## **STAFF REPORT AND RECOMMENDATION TO THE DESIGN COMMISSION**

CASE FILE: LU 17-180220 DZ

Ten West

**Proposal:** The applicant seeks Type III Design Review approval for exterior alterations to accompany a core and shell renovation and seismic upgrade of the five story Fliedner Building built in 1905 and located in the West End Subarea of the Downtown Subdistrict of the Central City Plan District. Exterior improvements include: storefront modifications at an existing lobby and at a new lobby, window replacements, stucco and terracotta repairs, paint, new exterior lighting, new skylight over an existing light well, and new penthouses at the stairs and elevator along with a new rooftop amenity space. The renovated building will feature office use on floors 2-5, and ground floor commercial use, as well as some additional commercial in the basement.

EXISTING EAST ELEVATION - BLACK + WHITE  
1/16" = 1'-0"

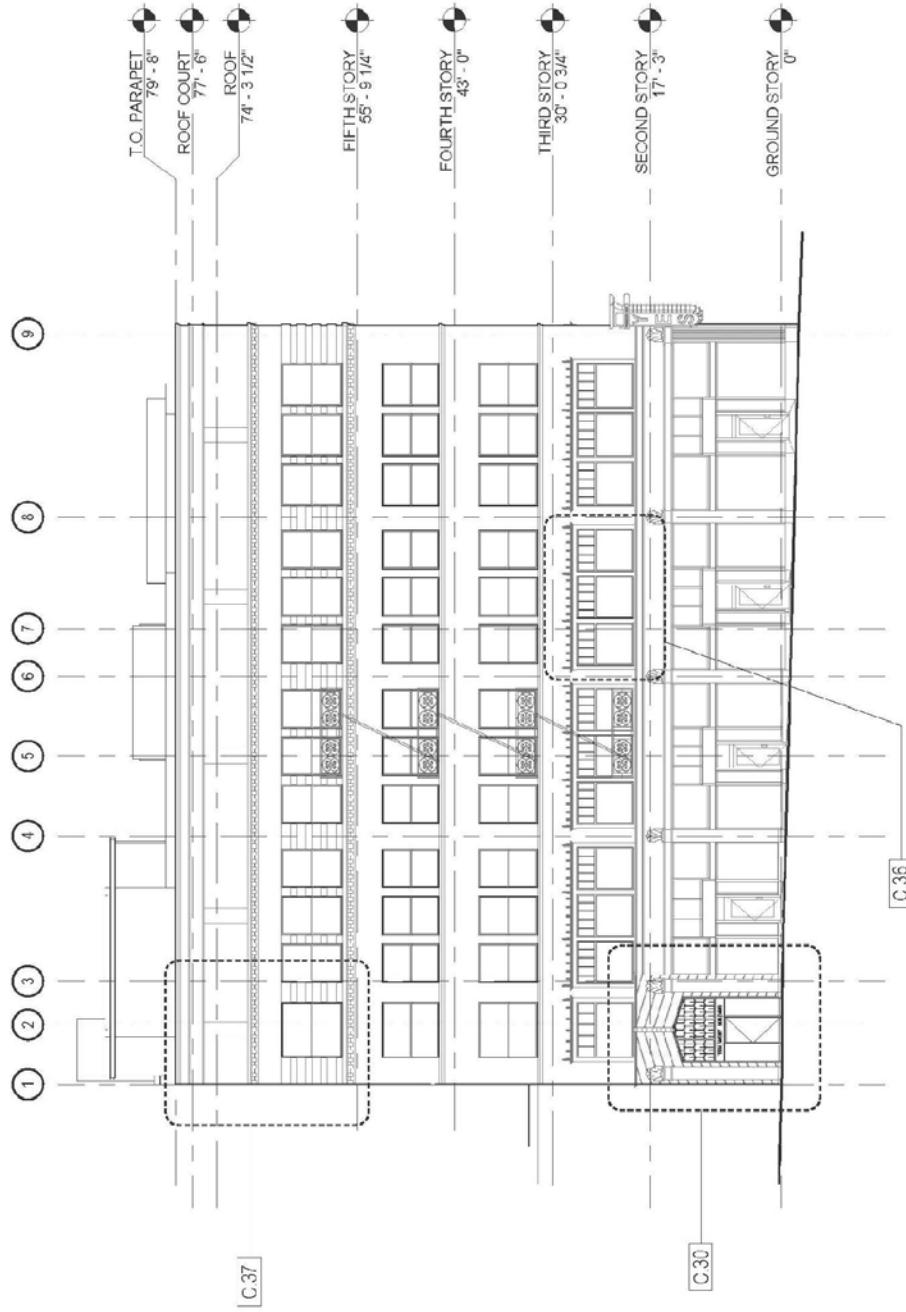
Staff has one outstanding concern with the proposal in reference to the guidelines. This is the alteration of the historic storefront bay facing onto SW 10th Ave located in the northeast corner of the building. The project proposes to change the existing bay which features a storefront door flanked by two display windows to a recessed storefront alcove with 2 out-swinging doors. This configuration is driven by a need for both a new lobby as well as a new exit passageway. The new lobby is for an elevator that gives access to a basement area slated to be occupied by a restaurant. The exit passageway will serve a new egress stair being added to the building. The addition of the second exit at the northeast corner allows the building to be occupied on the upper floors after decades of vacancy.

The existing condition is an attractive, intact historic storefront in a highly trafficked pedestrian zone. Given the consistency of its adjacent bays, Staff would have liked this bay to remain intact to maintain the consistent rhythm of the building's existing ground floor bays. The current proposal with two doors is a noticeable change to the bay. The proposed design is a response to building code requirements that present a need to keep the two spaces separated. The Applicant

and Staff have run multiple scenarios past City Plans Examiners to try to find a solution that both allows a new egress stair and its accompanying exit passageway while also allowing the storefront configuration to remain as is or very similar. Staff has finally concluded that all paths to fully retaining the existing condition while meeting building code have been exhausted. Discussions with Plans Examiners have illuminated the following:

Building code will not allow the new elevator to open into the exit passageway so the elevator and stair cannot share the existing single door. According to City Plans Examiners, this could be worked-around by adding a small vestibule space in front of the elevator with a door opening into the exit passageway. This would in theory allow the existing storefront to remain intact with a single door providing access from the exterior. The problem with this work-around is that there are strict regulations around what is allowed in an exit passageway (these are known as "interior finish limitations"). The code prohibits anything from being inside an exit passageway - so things commonly found in a lobby such as a building directory, plants, art, a bench or anything else would not be allowed. This means a pedestrian walking by would be looking into an empty room with two doors in it, not a more typical enlivened vestibule/lobby.

In addition to the sterility this would create facing onto the streetscape, the applicant would still need to alter the existing bay for the required second exit because the existing door does not meet current code requirements for accessibility in the following ways: The existing access to the door is too narrow and does not provide the required maneuvering clearances on the exterior side of the door. There needs to be at least 18" clear next to the latch side of the door; and the finished floor elevation is significantly higher than the sidewalk elevation, so the existing slope from the door to the sidewalk is much too steep for current codes. The applicant's proposal would lower the floor in this bay in order to reduce the slope to meet ADA and other code requirements.

In light of the building code challenges, Staff proposes a Condition of Approval that the storefront transom be preserved while the other proposed changes to the area beneath proceed (including recessing the rest of the wall plane and introducing a two-door configuration).

*With a condition of approval that the existing transom in the northeast storefront bay must be preserved, these guidelines are met, per Exhibit C.14.*
